Part Change Notification

Brief description of change(s) proposed

Attachment A

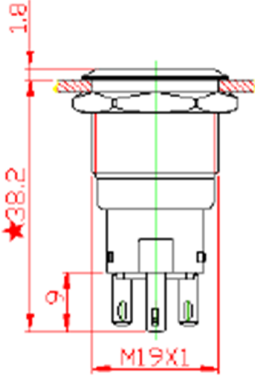
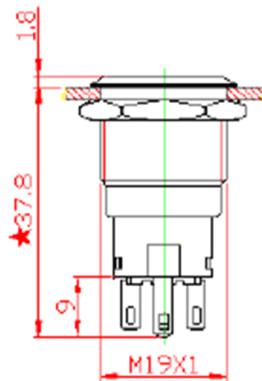
The switch base and shell case will be modified so the two parts can be fixed more securely once assembled.

Due to design change for switch base, different type of LED will be used and the consumption of LED will be better than current design.

Only following models will result differences (noted in *) in physical dimensions.

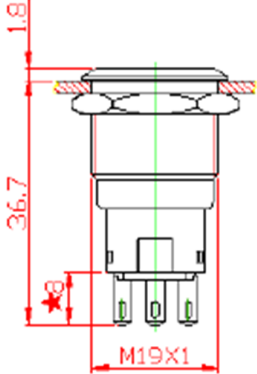
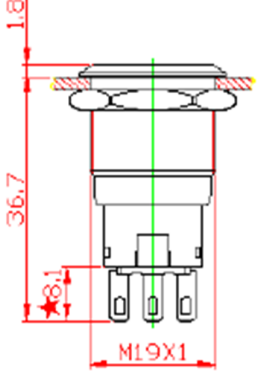
CURRENT TYPE			NEW TYPE					
LED Consumption		R, G, B, O	W, Y		R, G, B, O, Y	W			
	24V	6mA	5mA	24V	6mA	5mA			
		R, Y, O	B, W, G	R, G		B, Y, O, W			
	12V	12mA	11mA	12V	6mA	5mA	11mA		
		R	B, W, G	Y, O		R, G, Y	B	W	O
	6V	15mA	12mA	14mA	6V	8mA	7mA	12mA	9mA
